**Review in the light of scientific and
technical progress of exemptions 8(e),
8(f)(b), 8(g) and 14 and re-evaluation of
entry 8(j) of Annex II to Directive
2000/53/EC (ELV) (Pack 3) –**

Final

Prepared by Oeko-Institut e.V., Institute for Applied Ecology, and Fraunhofer-Institut for Reliability and Microintegration (IZM)

02 October 2019

Figure 7-1: Sample of a FCOL

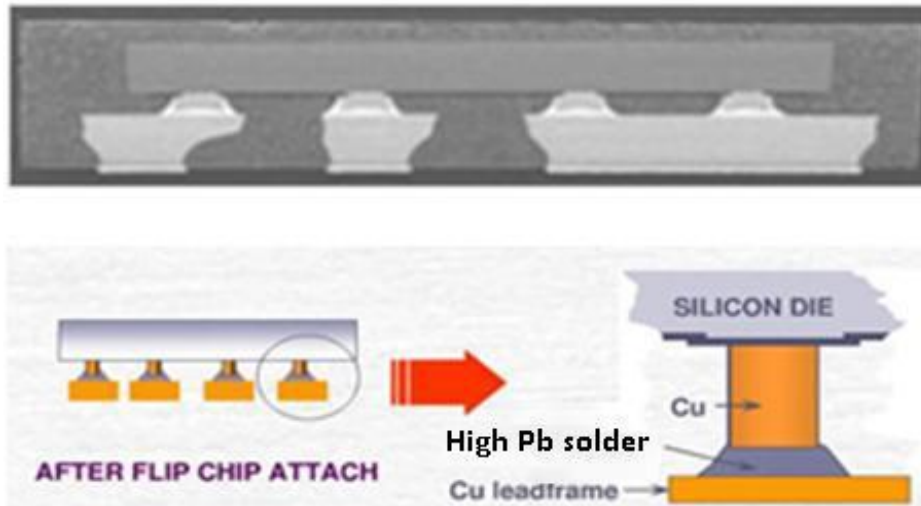
The yet provided information from ACEA et al. (2018 a) as reflected in section 7.4.2 on page 45 says that (lead-free) pillar sizes cannot be reduced to alleviate stress since the high current will then exceed electromigration limits. The statement seems to refer to retrodesigned older FCOL. It is not clear whether and how far this applies to new high current FCOL. According to ACEA et al. (2018 b), examples for these FCOLs are those listed under number 3 in the above Table 7-2. The context with the lead frame is not explained. Beyond the statement that electromigration plays a role, the answer does not further illustrate and explain the technical reasons why high currents and resulting electromigration require the use of lead on FCOLs with chips of less than 300 mm² while it seems to be irrelevant for other FCPs.

These statements do not answer the above technical questions. Moreover, ADI's statement only refers to SOT23-FCOL and thus cannot justify why the use of lead is generally unavoidable. Additionally, it is not clear whether the statement refers to retrofit FCOLs or new type FCOLs.

This explanation gives some insights, but is not a coherent and sufficiently comprehensible explanation why the high current FCOLs need to use lead despite of die sizes smaller than 300 mm² where the use of lead is avoidable for such die sizes in other FCPs.

Figure 8-3: Cracked laboratory glass samples with soldered contact on surface 4

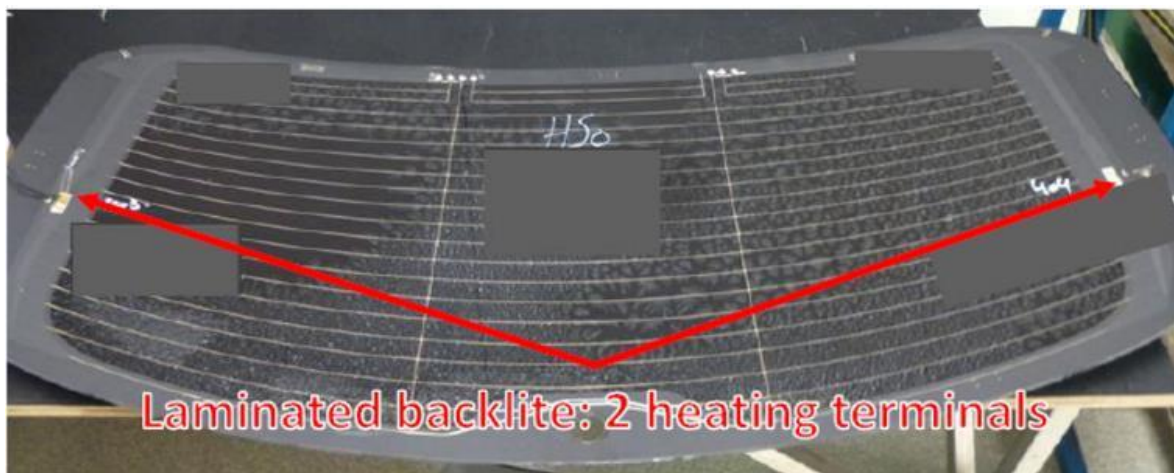
ACEA et al. (2018 a) actually present two results of laboratory trials that "[...] were performed on a large variety of connector designs, material composition and process conditions." They explain that the main concerns of *"Lead-free soldering for laminated glazings observed on this wide laboratory trial portfolio can be highlighted by the failures presented in [...]"* Figure 8-3 and Figure 8-4 on page 67 et sqq.

The consultants had, however, not asked for the reasons of failures and for physical evidence, but for substantial details of the test program behind the submitted evidence in Figure 8-3 and Figure 8-4 on page 67 et sqq. According to ACEA et al. (2018 c) *"The trial examples aim to show that, in summary, with indium alloy the industry could face a functional risk of connector disconnection while with other alloys the industry could face a quality risk of glass breakage."* ACEA et al. (2018 c) concede

The tests presented in Figure 8-3 and Figure 8-4 on page 67 et sqq. were both conducted on surface 4 of thin glass panes with only 1.6 mm thickness. Table 8-4 gives an overview of glass pane thicknesses used for LG.

Figure 8-4: Laminated backlight with heating grid and soldered contacts on surface 4

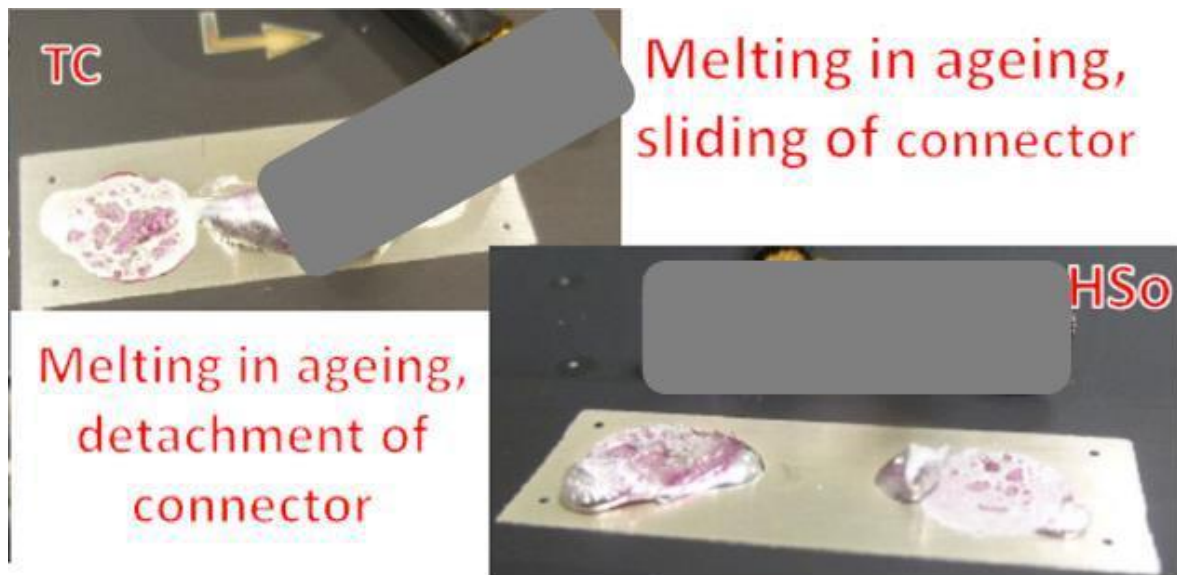
Additionally, Antaya questions the composition of the alloy and the soldering process parameters used for Test 2 as they are not explicitly stated or disclosed²³. As mentioned above, Antaya recognizes that not all indium-based alloys are optimal for soldering to laminated glazing.

The information presented in Figure 8-5 on page 67 is not an evidence that indium-based lead-free solders are principally not viable, even though they may not appropriate for all applications, as already assessed by Gensch et al. (2015).

Figure 8-6: Lead-free soldered laminated backlights with glass breakages starting at the soldered bus bars

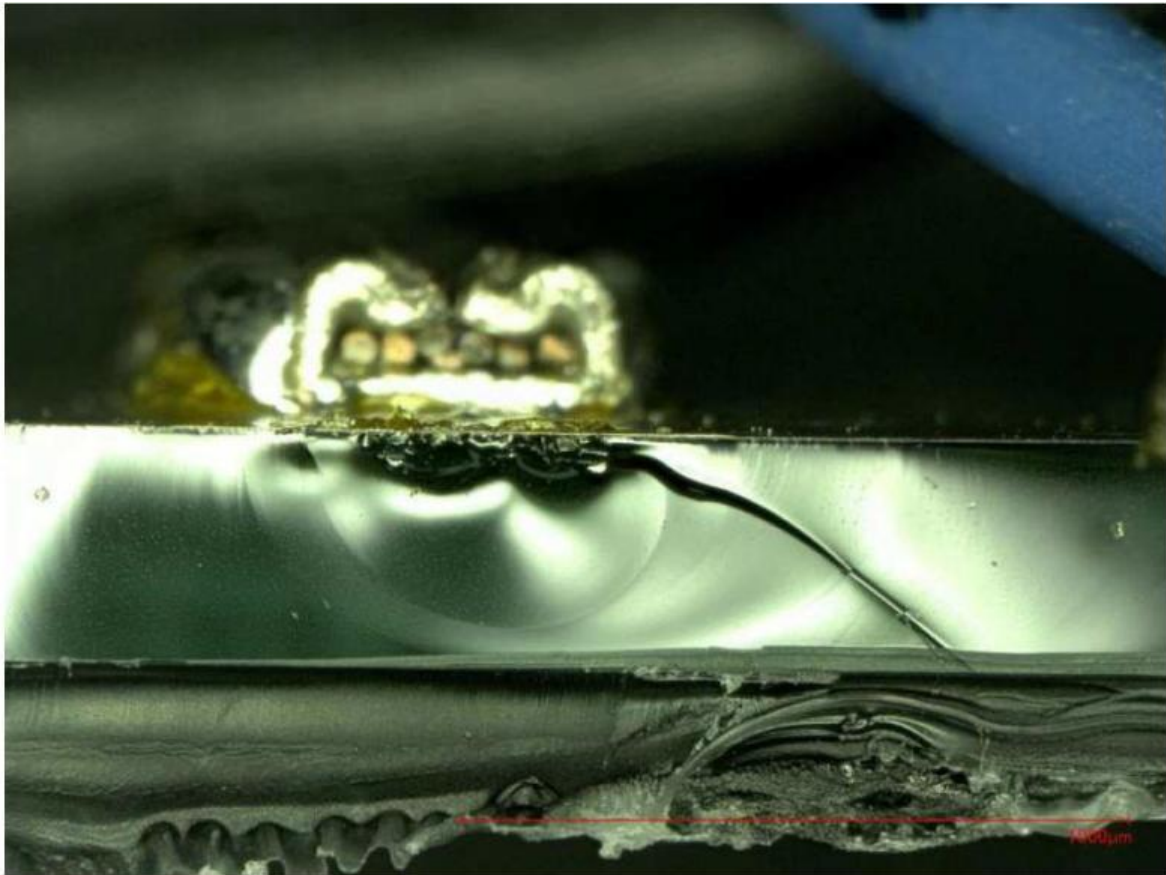
In Figure 8-6 on page 69 ACEA et al. (2018 a) additionally present a photo of a lead-free soldered LG that broke in a field test. They claim that the glass did not break after the manufacturer returned to lead solder. There is no information on the thickness of the glass panes, it is not discussed whether and how far the failure could have been avoided with different soldering profiles for lead-free solders, adapted connector geometries, or a different type of lead-free solder.
